# Manual 07 Update – Revision 5

## PJM Protection Standards

Stan Sliwa, P.E.  
Transmission Planning  
Planning Committee  
August 5, 2025

Figure 1. Acceptable Configuration

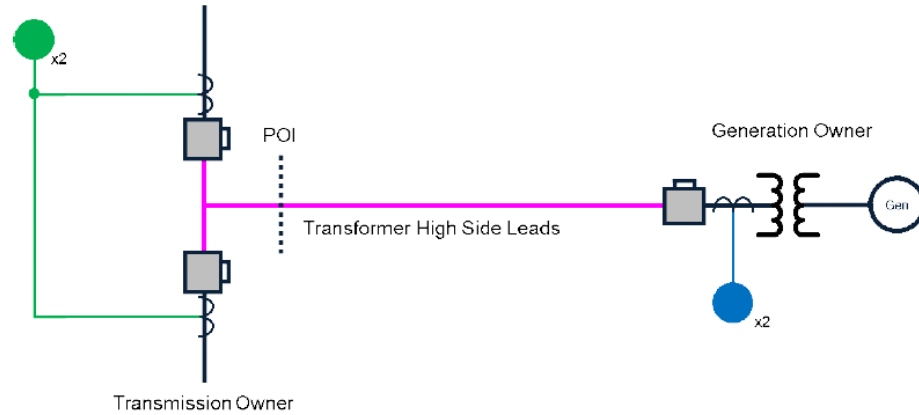
- Enhanced section 4.2 on transformer high-side lead protection with more details and added reference diagrams

The transformer high-side leads are required to be protected by two independent current differential schemes ~~or equivalent high-speed schemes~~. The schemes must utilize independent current sources and independently protected DC control circuits.

Transformer high-side leads shall not have infeed within the protection zone as experienced by the two independent current differential schemes. Transformer high-side leads shall not have more than two terminals as experienced by the two independent current differential schemes.

In Section 4.2.1 several examples of acceptable configurations are provided; this is not an exhaustive list. Other configurations of both the protection and phase conductor are possible while satisfying the requirements. Additionally, Section 4.2.1 provides a possible system configuration that is prohibited.
